1992 Corvette: Service Bulletin: Harsh 1-2 Upshift

Subject: HARSH 1-2 UPSHIFT INSTALL SERVICE PACKAGE
Model and Year: 1992 CAPRICE, CAMARO AND CORVETTE 1992 C/K, G, L/M, S/T TRUCKS
Source: Chevrolet Service Bulletin
Bulletin Number: 92-318-7A - (09/15/1992)

TRANSMISSION APPLICATIONS: SUBJECT: 1992 HYDRA-MATIC 4L60 Harsh 1-2 Upshift ;Install Service Package

Figure 1 - HYDRA-MATIC 4L60 Transmission Identification Information

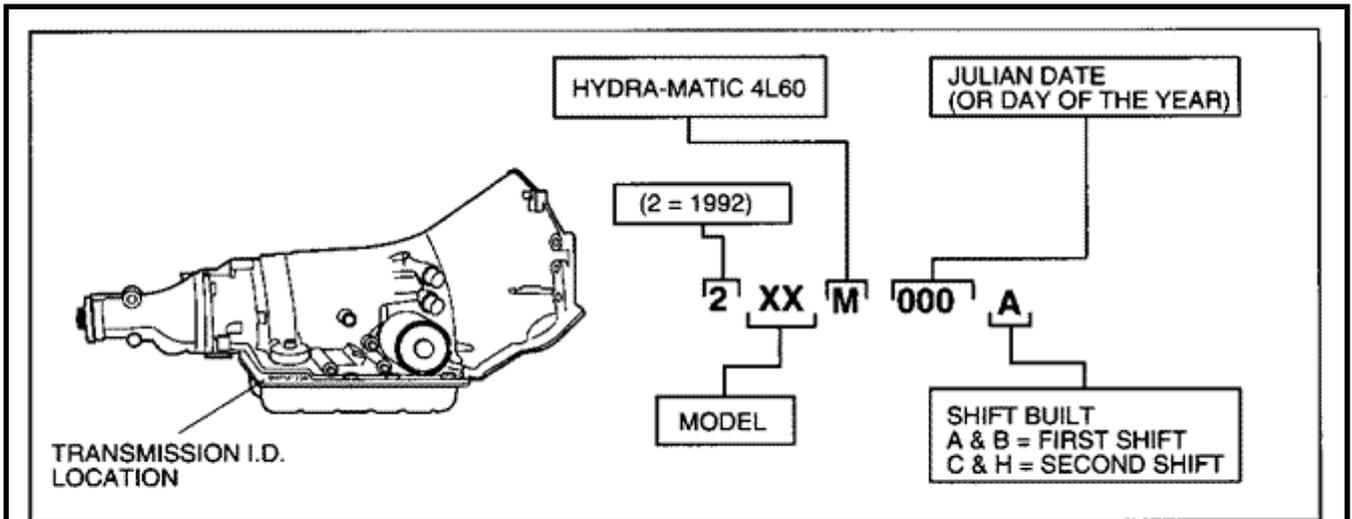
CONDITION (Figure 1):

Some vehicles equipped with a 1992 HYDRA-MATIC 4L60 transmission built between Julian Date 061 (March 1, 1992) and Julian Date 171 (June 19, 1992) may experience a harsh 1-2 upshift. NOTE: Once the transmission is brought to operating temperature, the condition may not be able to be reproduced until a "cold soak" (overnight) is performed.

Figure 2

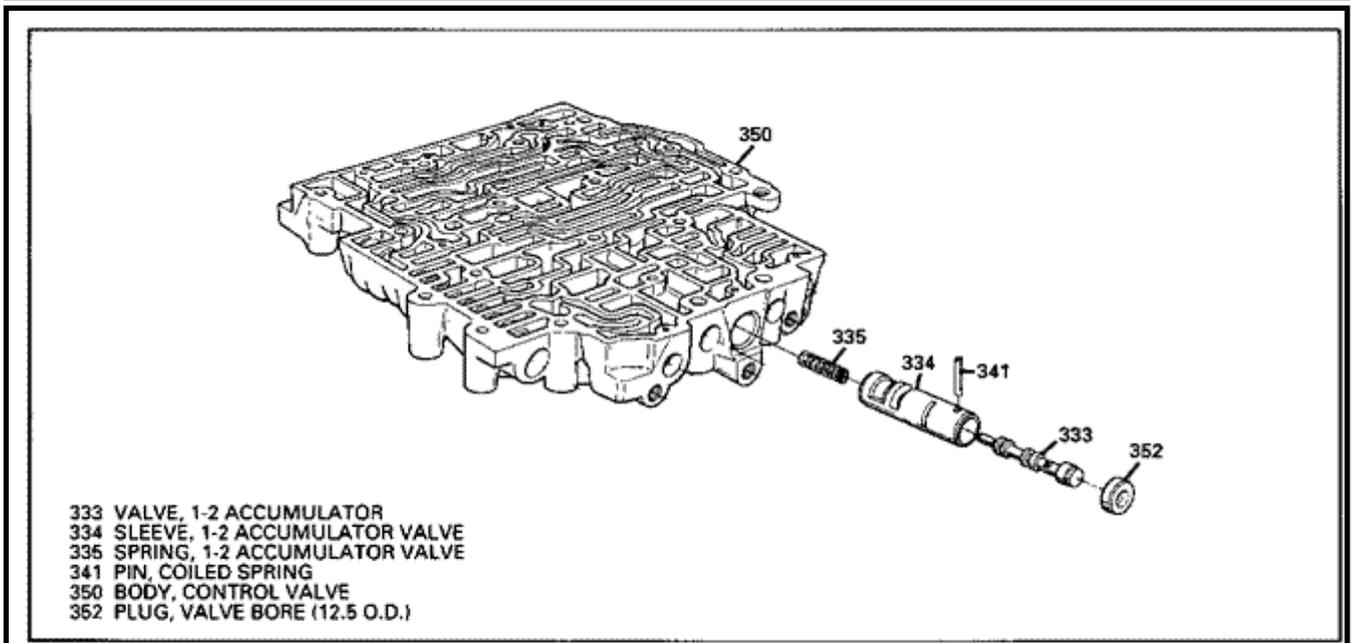
CAUSE:

The above condition may be caused due to a tapered 1-2 accumulator sleeve. The tapered bore may cause the 1-2 accumulator valve to stick in the bottom of the bore.

CORRECTION (Figure 2):

To improve the 1-2 shift, install the service package listed in this bulletin. A 1-2 accumulator valve and 1-2 accumulator valve sleeve (which, normally, is not serviceable) is included in the package.
